06V-485
(28 pages)

Date: December 11, 2006
To: Pat Wallace
From: Renato Aime – Ducati North America
Subject: Safety Recall Campaign Notification

Safety Defect and Noncompliance Report Guide for Vehicles
PART 573 Defect and Noncompliance Report³

Recall Bulletin**RCL-06-0--****DNA**

PICTURE 1

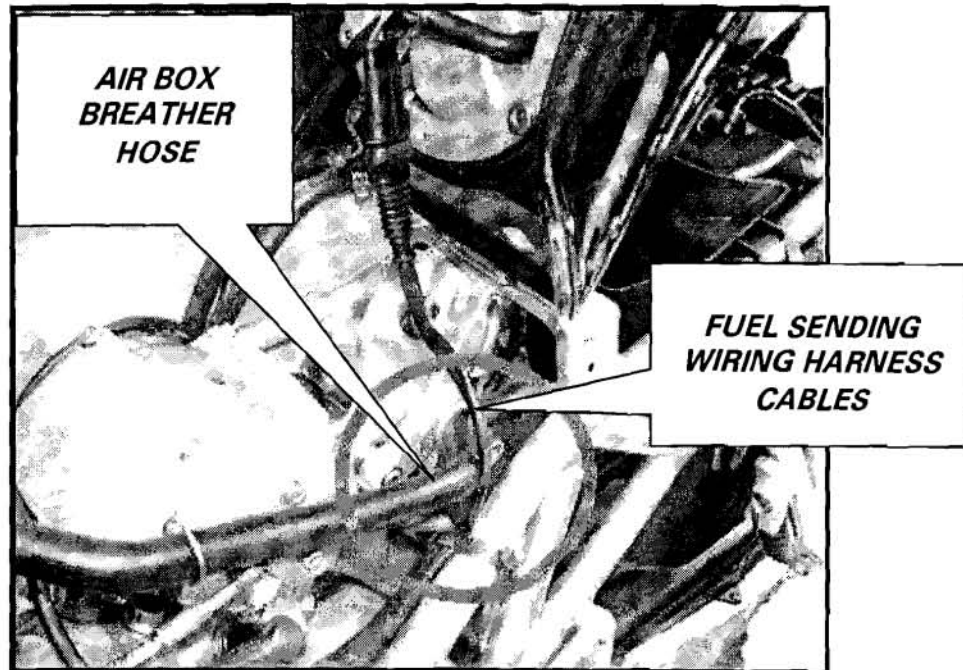
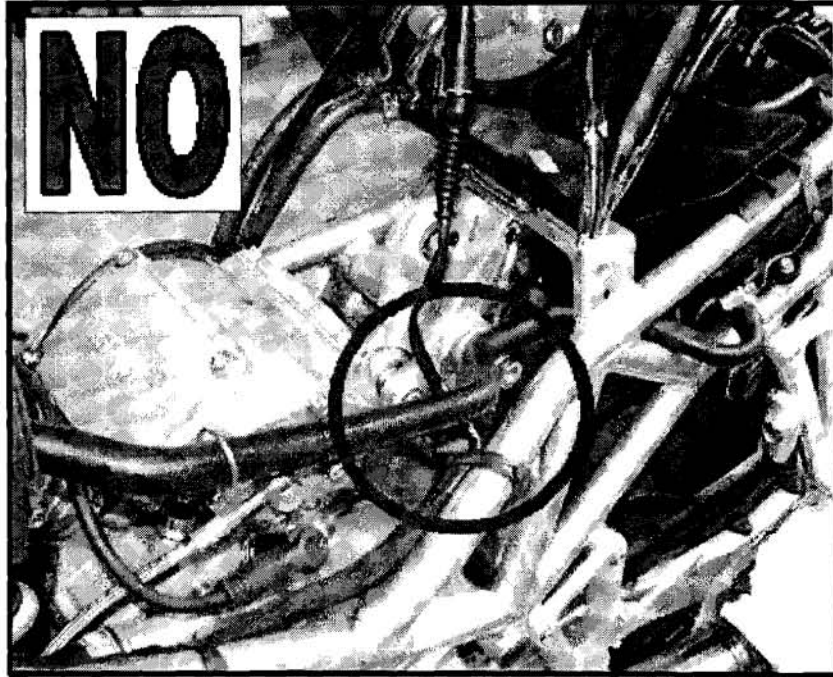
Lift the fuel tank and check that fuel pump cable is routed outside of the air box breather hose (as shown in picture 1).

Picture 2 shows incorrect cable routing that shall be rectified and set as shown in picture no. 1.

It is necessary to reposition it because cable could touch the vertical cylinder exhaust pipe.

Lift the fuel tank and check that the fuel sending unit wiring cables is routed outside the air box breather hose as illustrated in the instructions attachment.
